Addendum No. 1

PROJECT: Addition & Interior Renovations for the
Marlboro Free Library

ARCHITECT
PROJECT N°: 23•46•06

DATE: 3 June 2025

SK1-S101-1

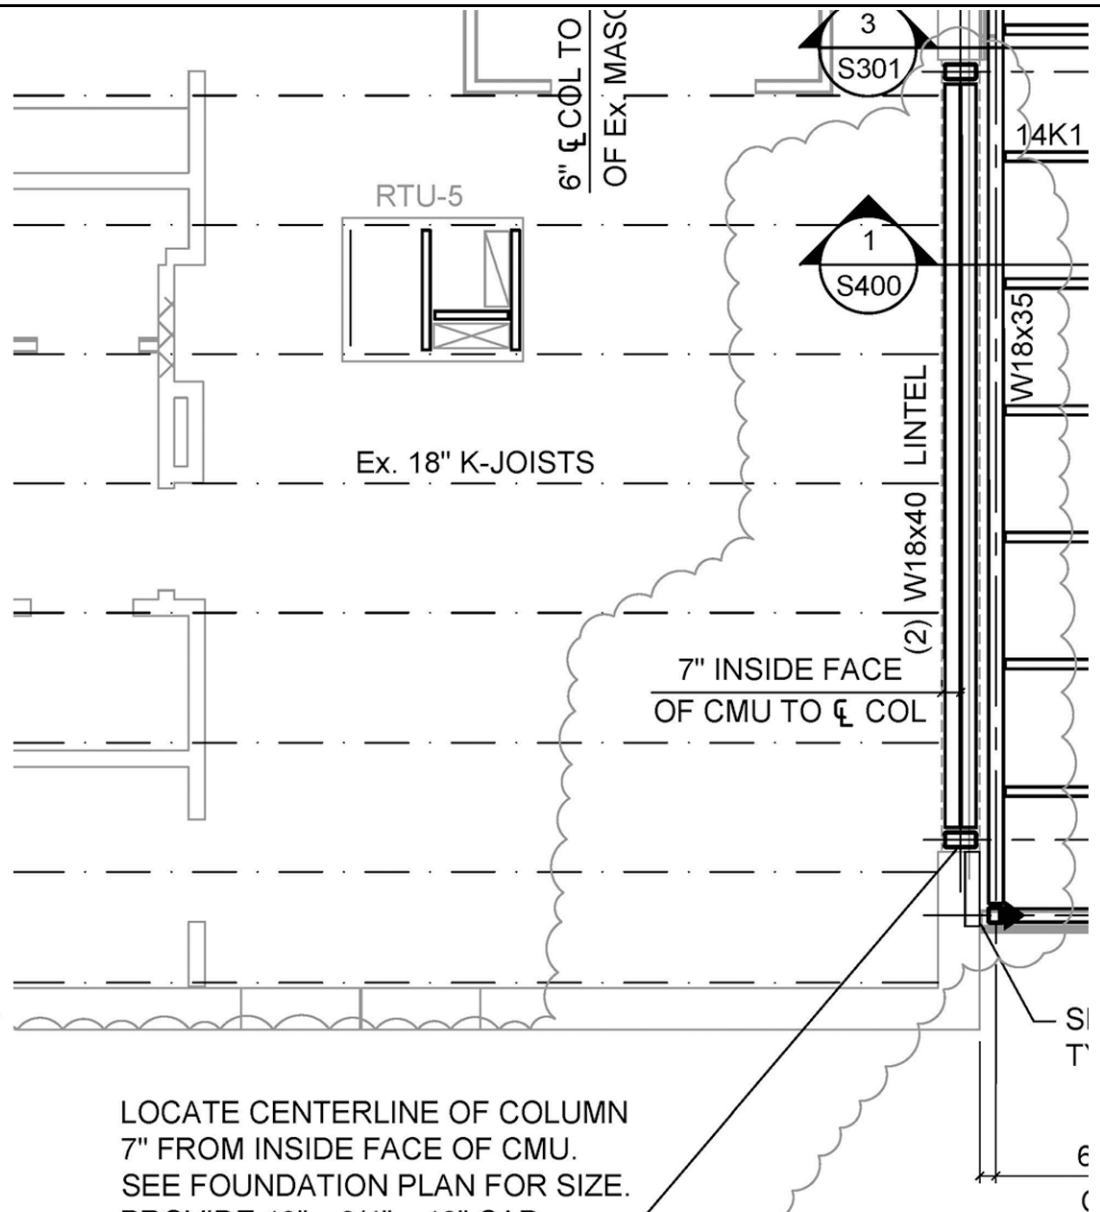
14. S101 Foundation Plan

Clarification for Columns B and C; see attached SK1-S101-1.

LOCATE CENTERLINE OF COLUMN
7" FROM INSIDE FACE OF CMU.
SEE FOUNDATION PLAN FOR SIZE.
PROVIDE 13" x 3/4" x 10" CAP
PLATE. TYPICAL 2 COLUMNS

WHERE NEW FRAMED WALL INTERSECTS EXISTING MASONRY, SHORE TOP OF EXISTING FACE BLOCK WALL FOR 300 PLF AND REMOVE EXISTING FACE BLOCK BELOW ROOF FRAMING. RESUPPORT FACEBLOCK TO REMAIN w/ 3 5/8" x 16 GA. STUD WALL, w/ 14 GA TRACK TOP AND BOTTOM. FASTEN PER DETAILS ON S500.

SK1-S102-1

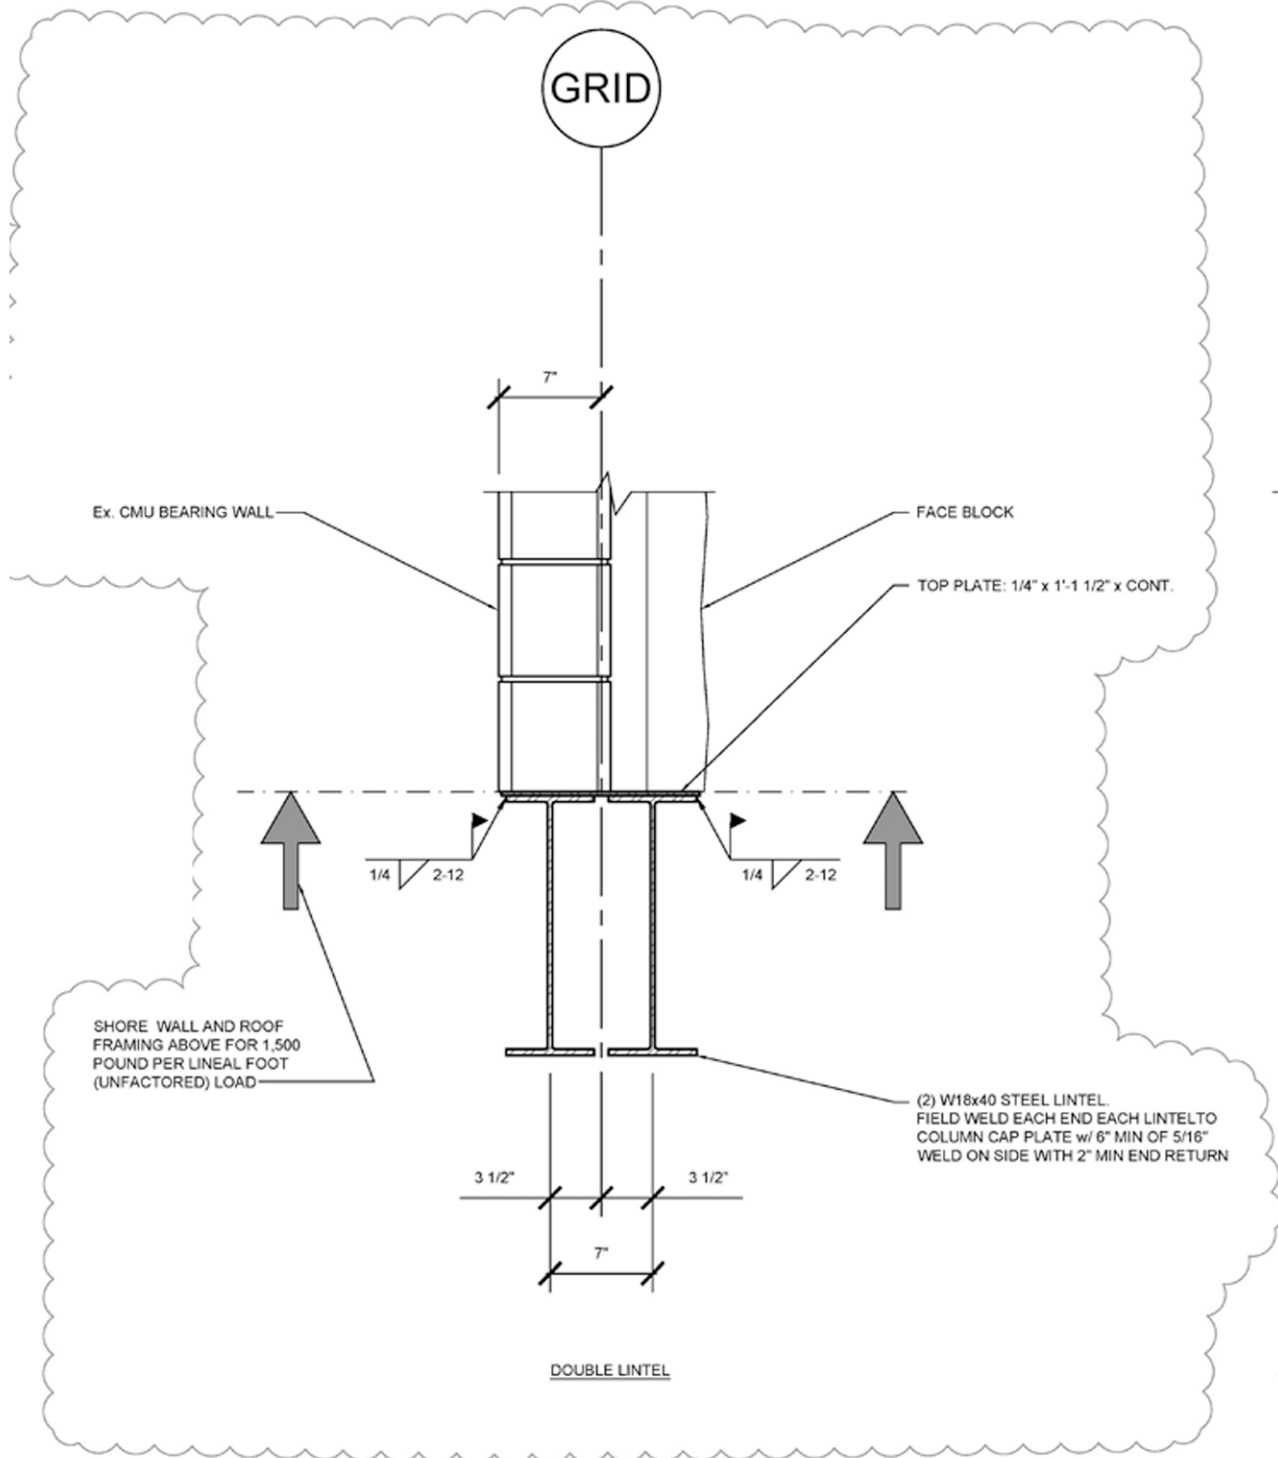
15. S102 First Floor Framing Plan

Clarification for lintel and new masonry opening; see attached SK1-S102-1.

LINTEL SECTIONS

SK1-S400-1

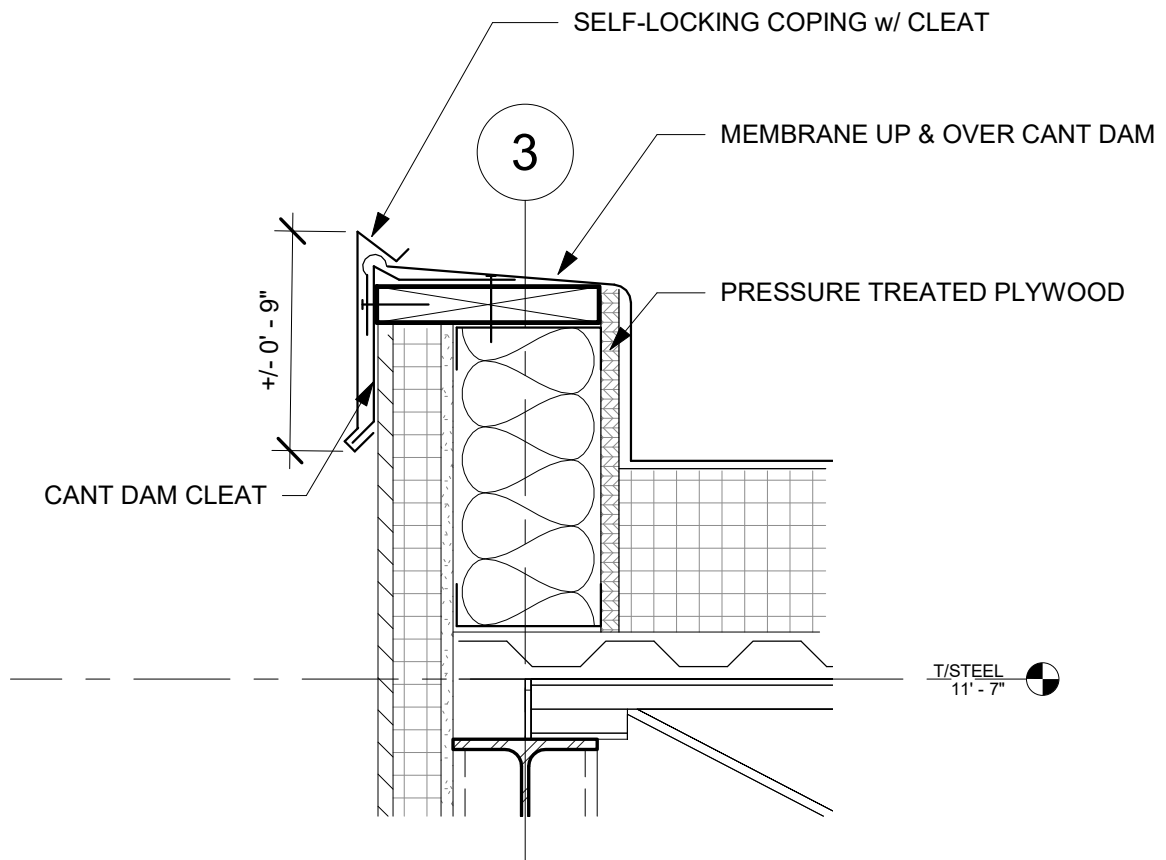
18. S400 Typical Masonry Details

Add Double Lintel Section; see attached SK1-S400-1.

SK1-A302-1

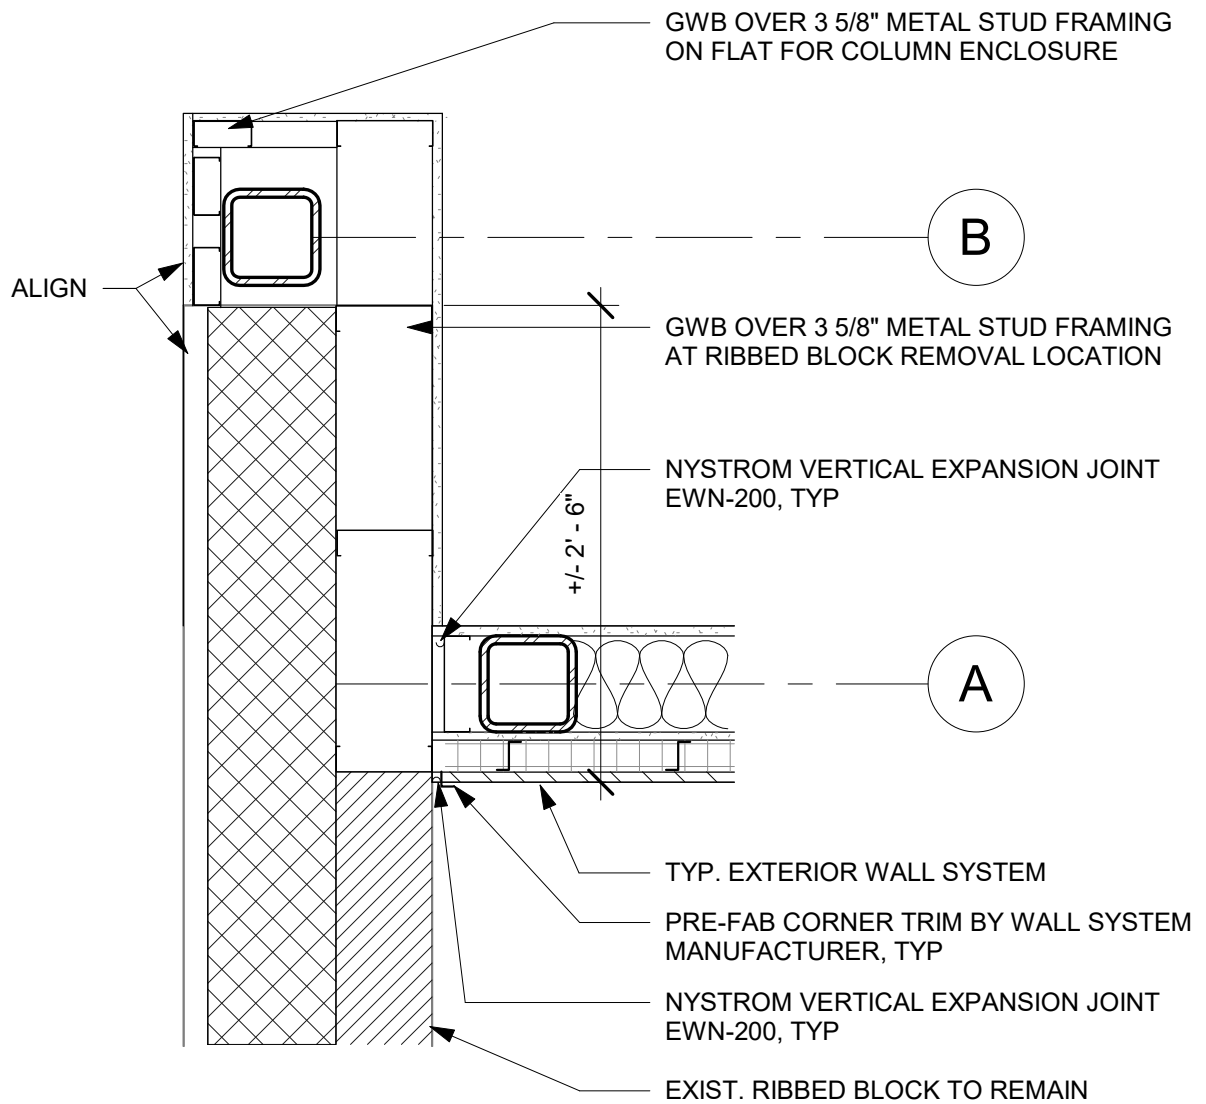
29. Detail 1/A302

Replace detail with Sketch SK1-A302-1 attached.

① PLAN DETAIL @ ADDITION
1" = 1'-0"
